**(Product Change Notification)**

PCN# 030115

**Change Description:** In order to provide consistent colors in our 972 series hoods/backshells, Norcomp has established "Pantone Color Numbers" for this series. We will begin shipping the new "Pantone Colors" over the next 3 months.

**DESCRIPTION: 972 SERIES D-SUB SLIM-LINE BACKSHELL**

972-YYY-01SRY1

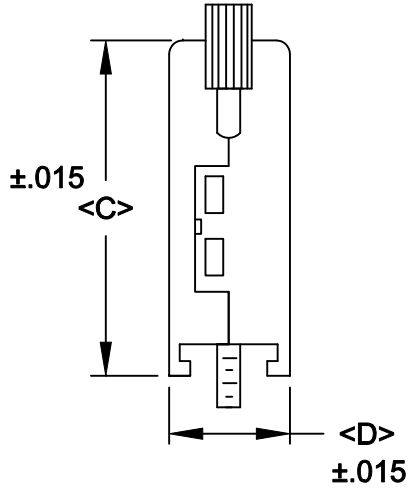
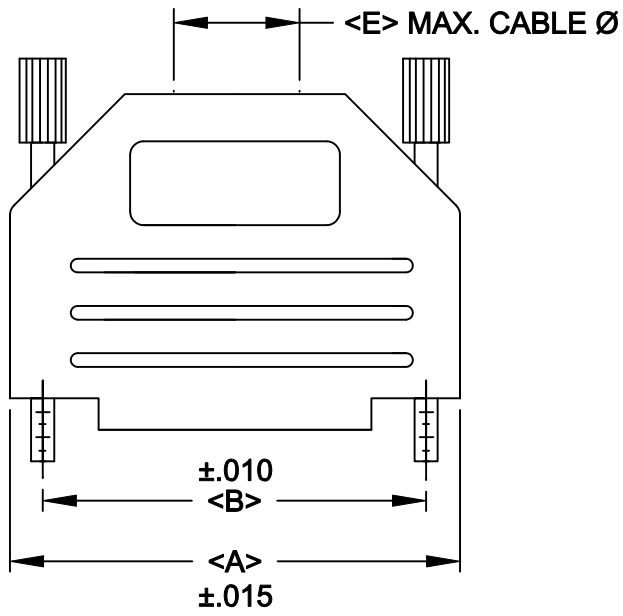
**\*\*SEE PAGE 2 FOR PANTONE COLOR CODES**
